**REGULAR MEETING OF THE UNITED LAGUNA HILLS MUTUAL
ARCHITECTURAL CONTROL AND STANDARDS COMMITTEE**

Tuesday, November 28, 2017

DATE: November 28, 2017
FOR: Architectural Control and Standards Committee
SUBJECT: Variance Request: Paul S Scottberg, 271-B (Majorca, Plan 9)
Bathroom Remodel

DATE: November 28, 2017
FOR: Architectural Control and Standards Committee
SUBJECT: Variance Request: Jean Maroney of 413-A (Madrid, 4)
Bathroom Addition, Change of Room Use, Window Addition, and
Installation of Resized Window in Living Room

EXISTING FLOOR PLAN

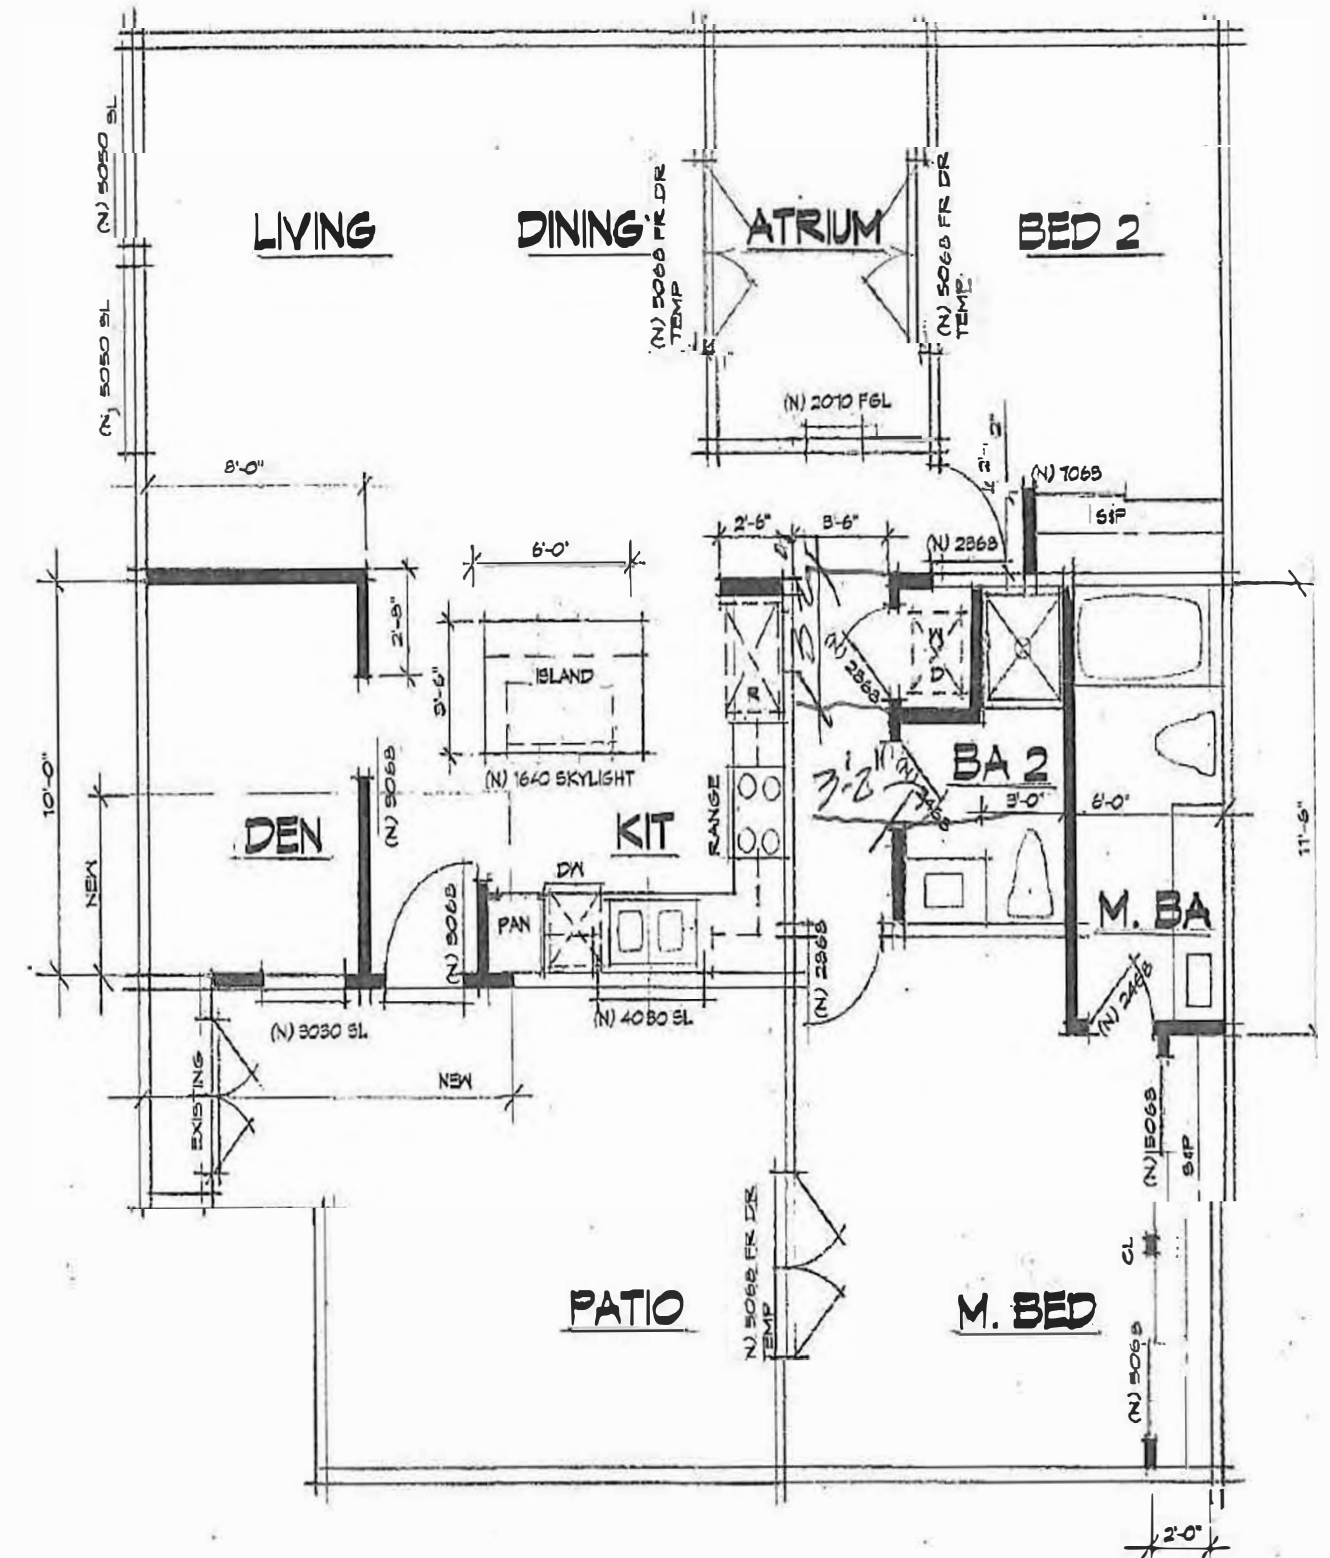
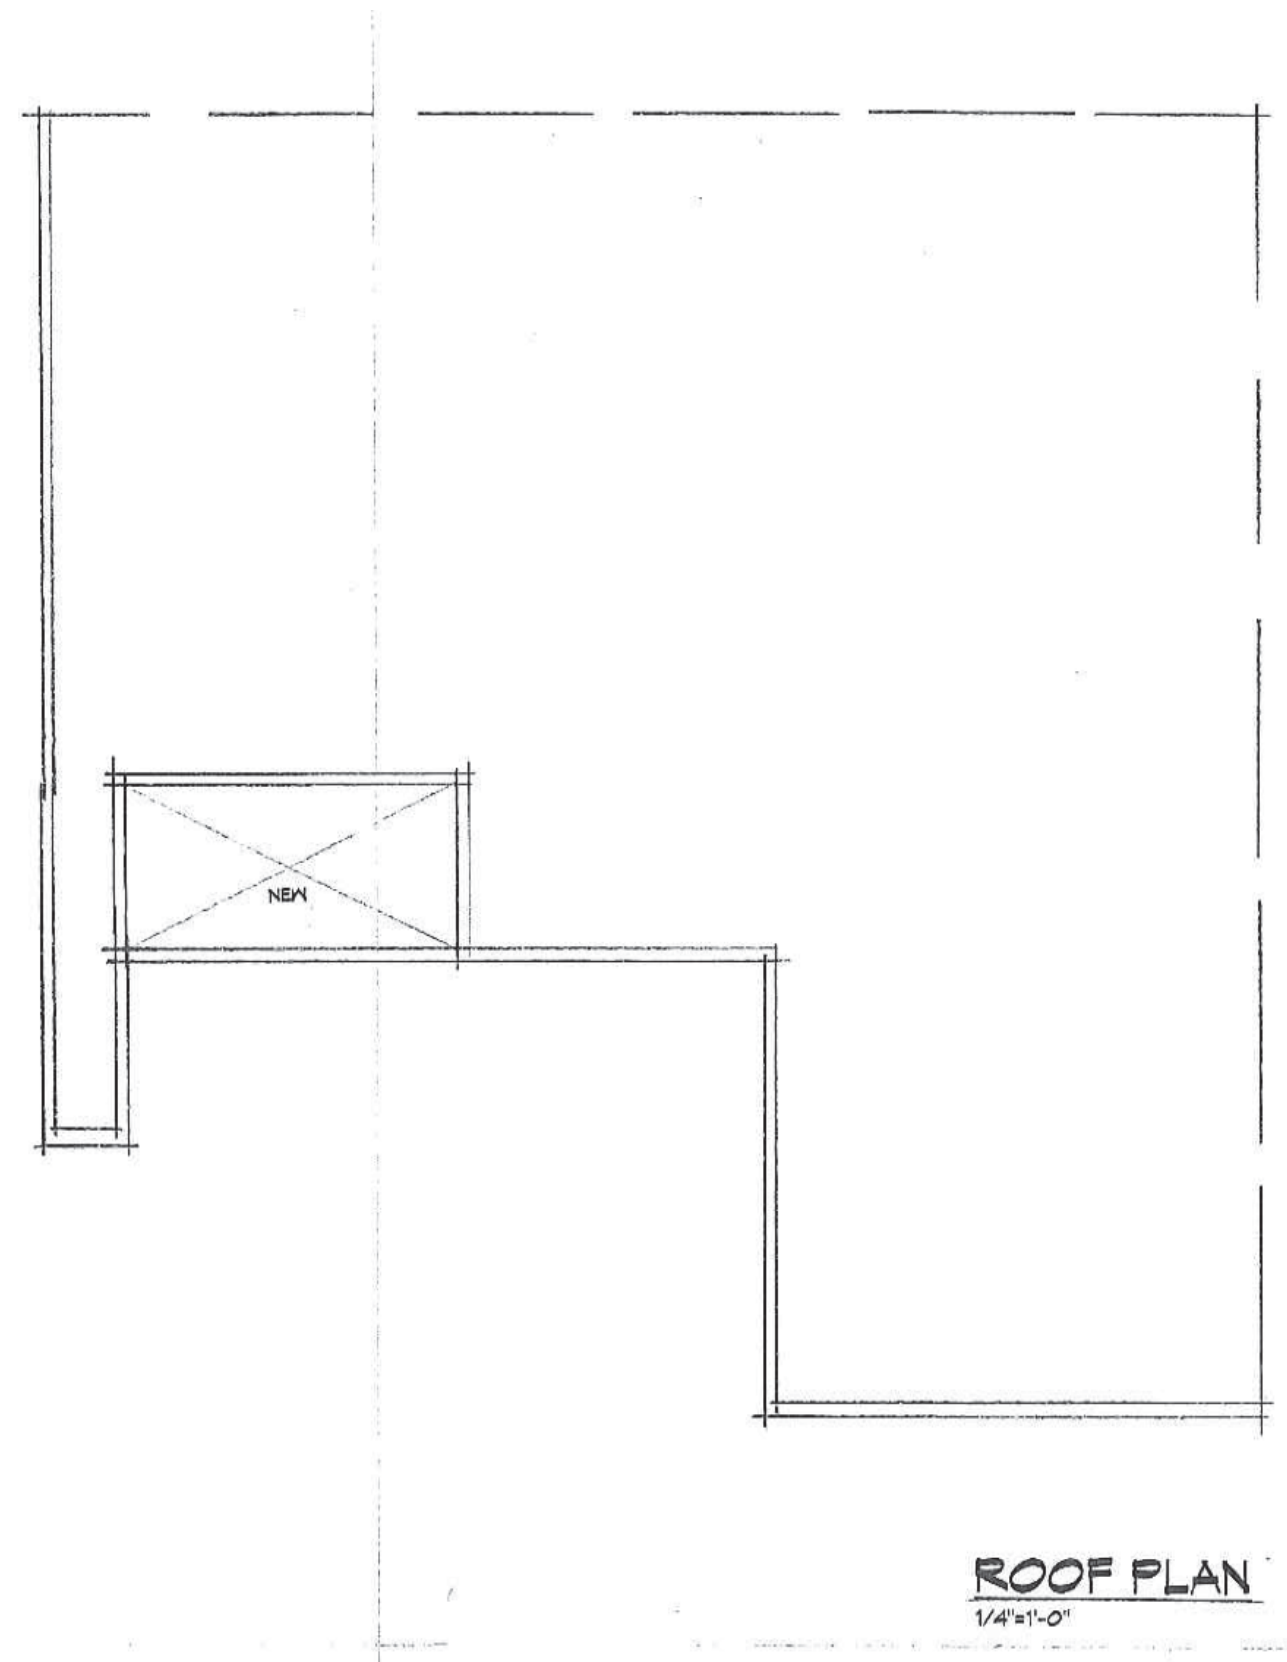
The proposed bathroom split involves relocating the master bathroom closet to the adjacent wall to allow the bathroom footprint to be extended 3 feet into the bedroom. A door would be added from the master bedroom to create an en suite. A new partition wall would be constructed to separate the bathroom. In the new guest bathroom, a shower is proposed along with a toilet and small vanity. An additional partition wall would be constructed to accommodate a washer/dryer closet which would be accessible from the hallway.

Ms. Lacombe proposes to replace the existing master bedroom window, which is 6 feet wide and 4 feet tall, faces the patio, with French doors measuring 5 feet wide by 6 feet 8 inches tall. A standard exists for a door replacement measuring 6 feet wide by 6 feet 8 inches tall; the Standard indicates a sliding glass door for the replacement.

Finally, Ms. Lacombe proposes to replace the existing windows and sliding glass door to the atrium with matching French doors which are 5 feet wide by 6 foot 8 inches tall, would be located opposite each other, leading to the guest bedroom and dining room.

Example of roof line after room addition.

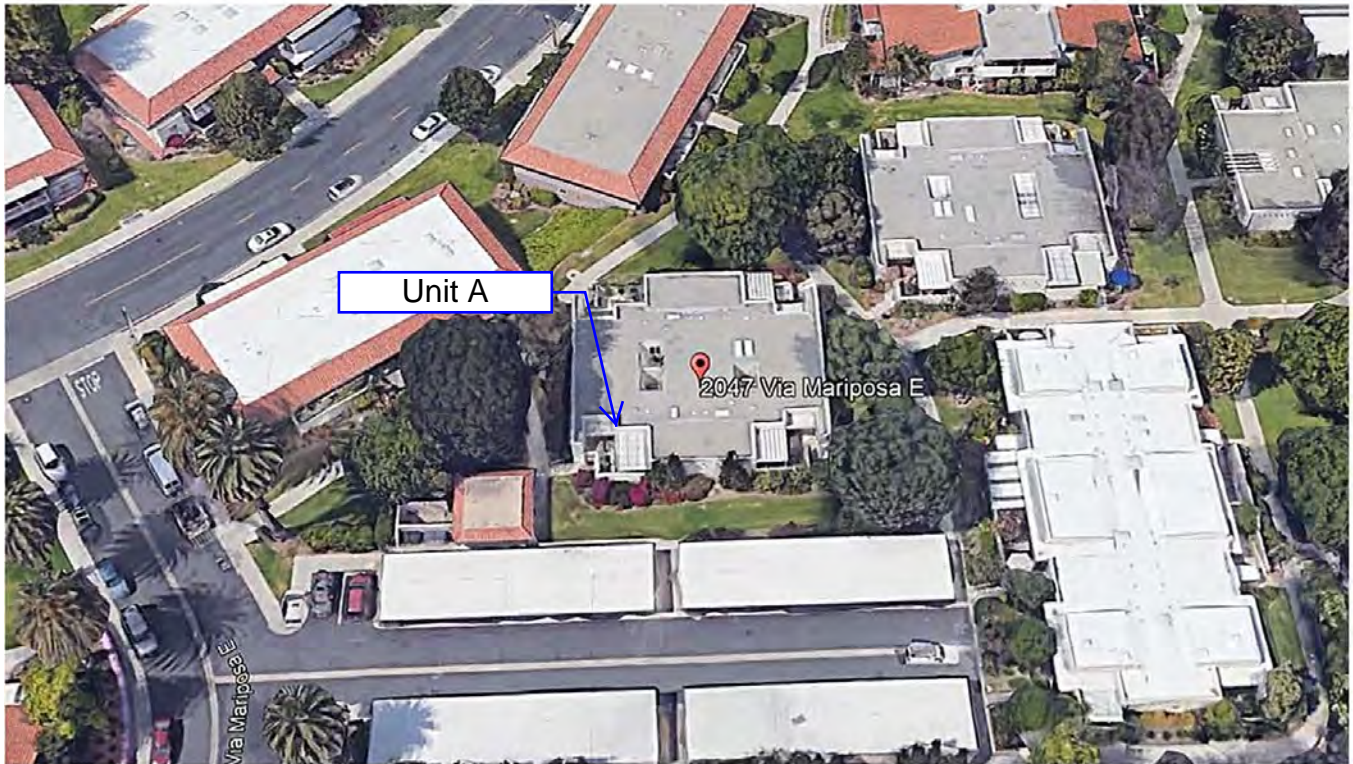
I Would like to add a room off of livingroom into existing patio w/ added window + new front door location.

2054-F

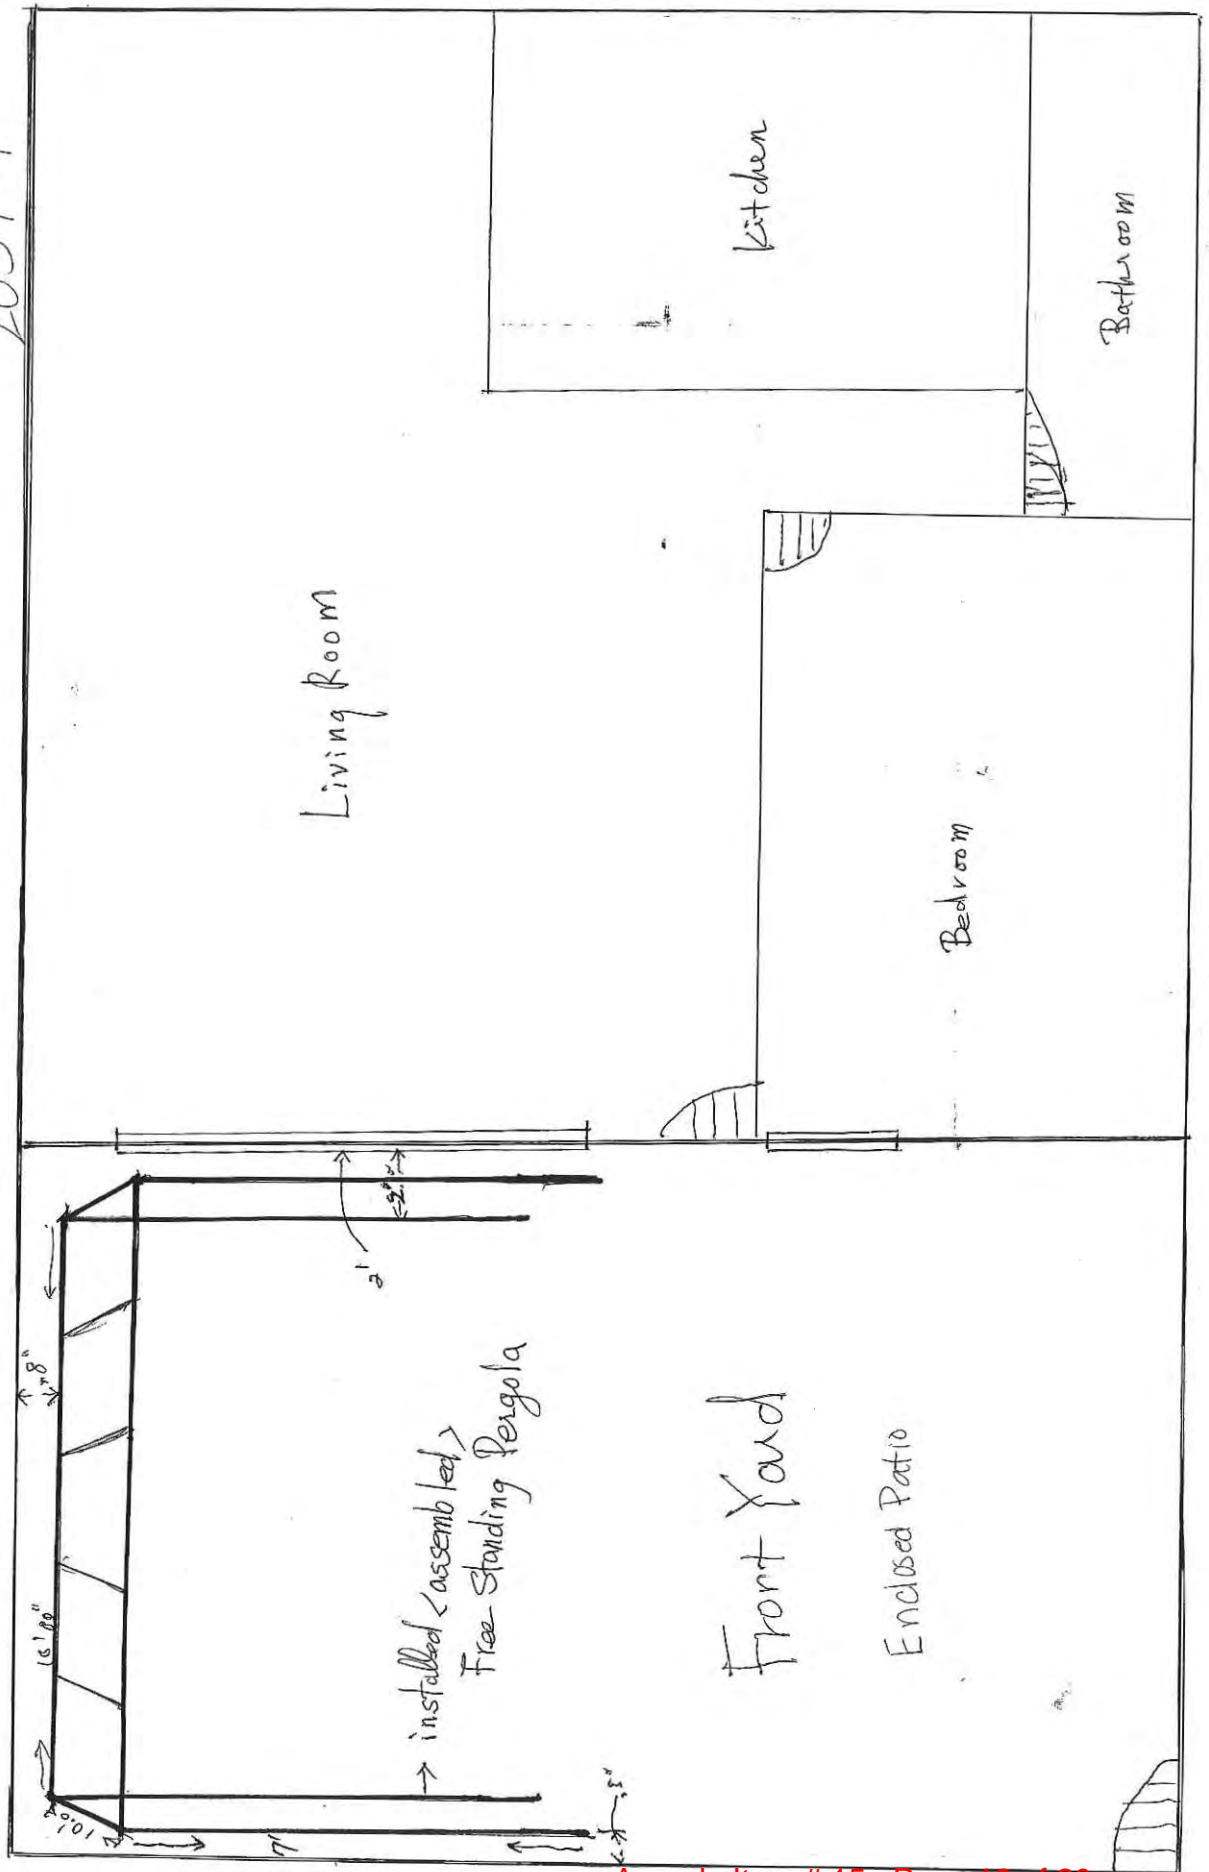
On June 9, 2017 Staff received notification of a non-compliant structure located in the front patio of unit 2054-F. Following a site visit, Staff found a non-approved patio cover type structure (pergola) on the front patio of 2054-F. Mutual Member, Mr. Danny Yeam, was contacted and given notice to remove the structure or apply for a variance within 30 days. Within 30 days, Mr. Danny Yeam of 2054-F of Via Mariposa E submitted a Variance Request (See Attachment 1) to retain the pergola.

There is no Mutual Standard for free standing structures to provide cover on patios.
